COUNCIL ASSESSMENT REPORT

Panel Reference	PPSSEC-191
DA Number	DA321/2020/2 (PAN-197451) – Section 4.55(2) Modification Application
LGA	Woollahra Municipal Council
Proposed Development	Existing Consent: Demolition of existing structure and construction of a shop top housing development Proposed Modification: Internal and external modifications to the approved shop top housing development with basement parking
Street Address	19-27 Cross Street DOUBLE BAY (Lot 100 of DP 617017)
Applicant/Owner	Applicant: Grand Noble Capital No 3 Pty Ltd Owner: Tri-Anta Pty Ltd
Date of DA lodgement	23 February 2022
Total number of Submissions	One (1)
Number of Unique Objections	
Recommendation	Approval
Regional Development Criteria (Schedule 7 of the SEPP (State and Regional Development) 2011	Pursuant to Clause 123BA(2) of the EP&A Regulation 2000, this matter is to be determined by the SECPP, the subject Section 4.55(2) Modification Application meets the referral criteria as set out in Schedule 1 of the Instruction, as it involves a departure of development standards by more than 10%.

SYDNEY EASTERN CITY PLANNING PANEL SECTION 4.55 DEVELOPMENT APPLICATION ASSESSMENT REPORT

ITEM No.	0.0
FILE No.	PP

Level 6 Roof – Proposed

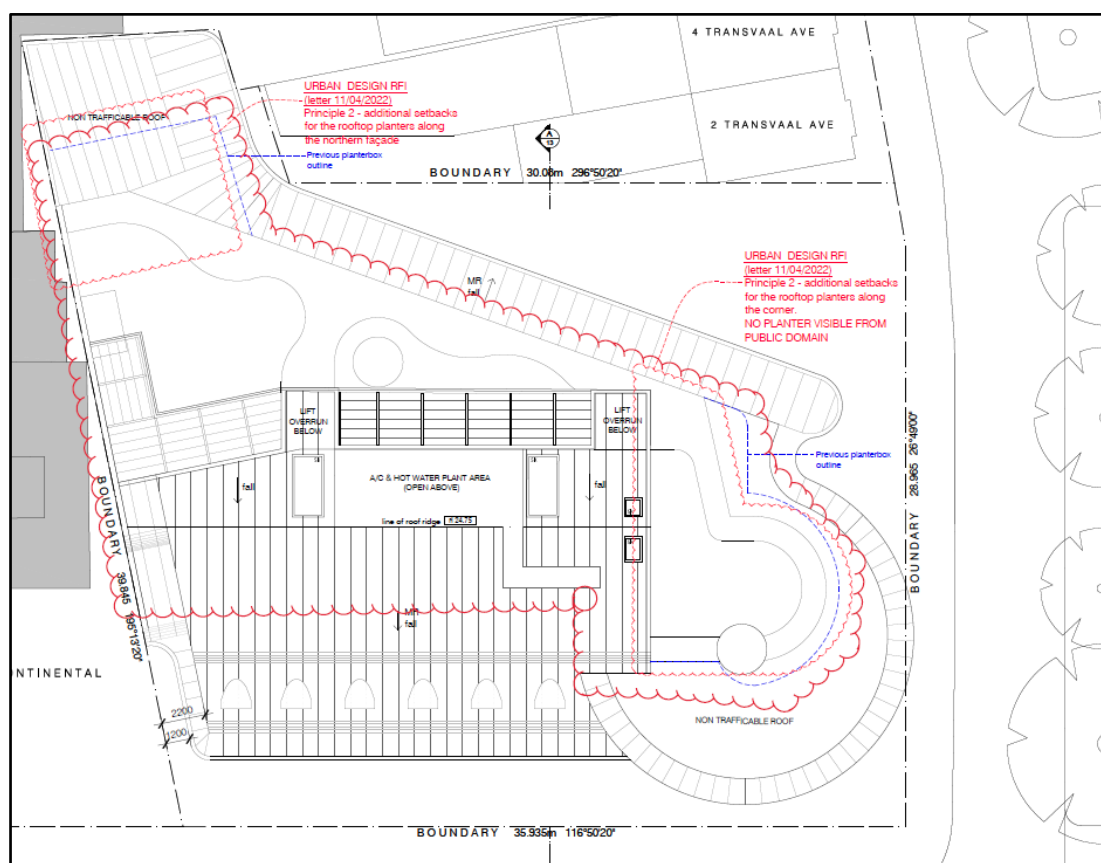
Principle 1: Context and Neighbourhood Issue	<i>Retain the approved geometry of built form along the corner by removing the provision of rooftop terrace and planter boxes for Unit 5.01.</i>	<i>Additional setbacks have been proposed for the rooftop planters at the corner.</i> <i>As per the drawings, no planter is visible from the public domain which has been illustrated through view analysis diagrams along Transvaal Avenue and Cross St.</i>	<i>The amendments do not comply with the recommendation which was to remove the rooftop terrace and planter boxes for Unit 5.01. However, additional setbacks have been provided to this terrace which contribute to a reduction in visual bulk and the impact of the smaller terrace is now considered minor. In order to ensure the visual impact of the planters remain minor, the planter height should be dimensioned on all drawings to be no higher than 700mm.</i> <i>Additionally, to minimise the visual impact of the spa for Unit 5.01 and allow the landscape planter to be continuous, the spa should be relocated to sit within the area allocated to the rooftop terrace.</i>

Principle 2: Built Form and Scale	<i>Provide additional setbacks for the rooftop planters along the northern façade and no part of the planter or rooftop terrace should extend beyond a line extending from the southern boundary of 2 Transvaal Avenue</i>	<i>Amended architectural drawings show additional setbacks for the rooftop planters along the northern façade and no part of the planter or roof top terrace extends beyond the line extending from the southern boundary of 2 Transvaal Avenue.</i>	<i>The amendment is substantially in accordance with the recommendation.</i>
Principle 2: Built Form and Scale Principle 6: Amenity	<i>Increase setbacks of habitable rooms from the north-western boundary of the site along 6 Transvaal Avenue to comply with the approved DA.</i>	<i>Approved DA setbacks have been reinstated.</i>	<i>The amendment is substantially in accordance with the recommendation.</i>
Principle 6: Amenity	<i>Provide screening to the Bedroom 4 window of Unit 5.03.</i>	<i>Screening to the window of Bedroom 4 of Unit 5.03 has been provided.</i>	<i>The amendment is substantially in accordance with the recommendation.</i>

- The rooftop planter height should be clearly dimensioned on all drawings and be no more than 700mm high;
- The spa should be relocated to sit within the rooftop terrace of Unit 5.01; and
- The soil area for the proposed *Zelkova serrata* (Japanese Elm) should be increased to be consistent with the minimum soil area set by the ADG (3.5m x 3.5m for a small tree).

Section AA Excerpt Showing Additional Height (Source: GSA Planning)

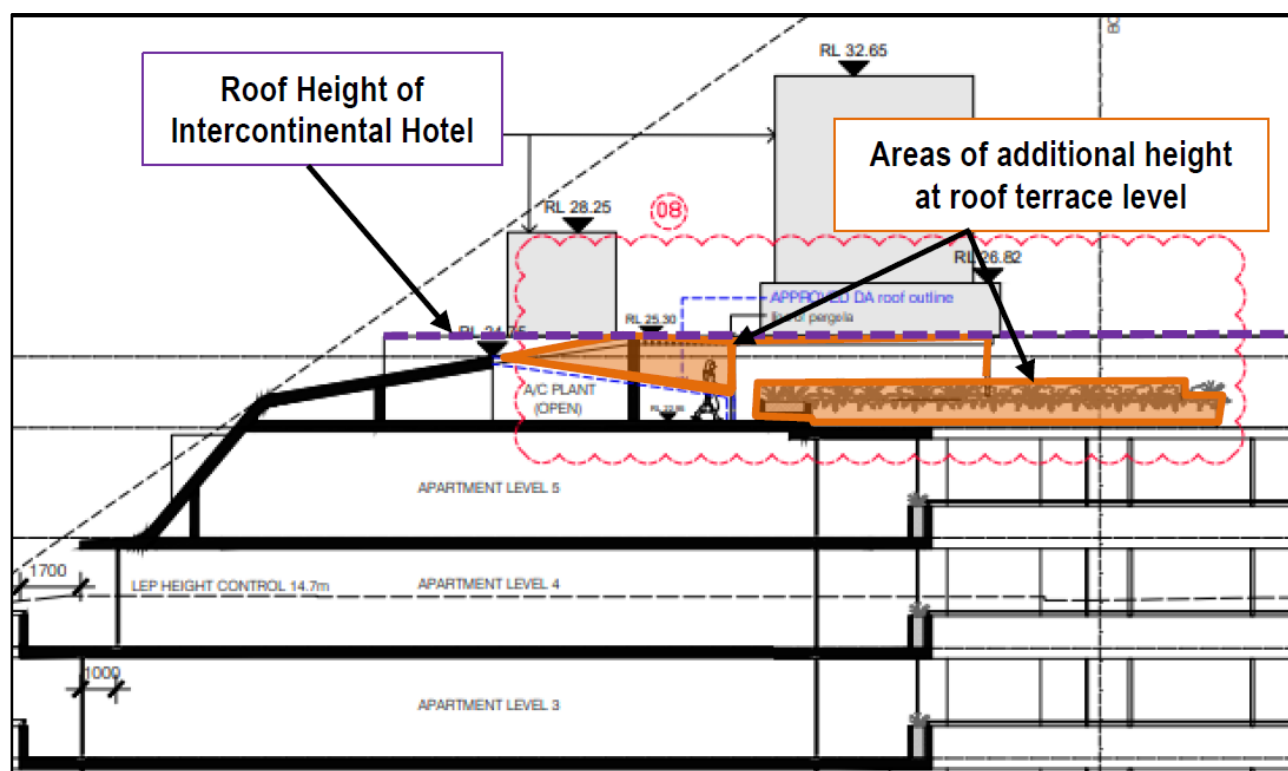
The proposed modifications do not comply with the maximum building height prescribed by Part 4.3(2) of Woollahra LEP 2014.

Notwithstanding this, the proposed additional height remains consistent with the relevant objectives under Part 4.3(1) of Woollahra LEP 2014 in the following manner:
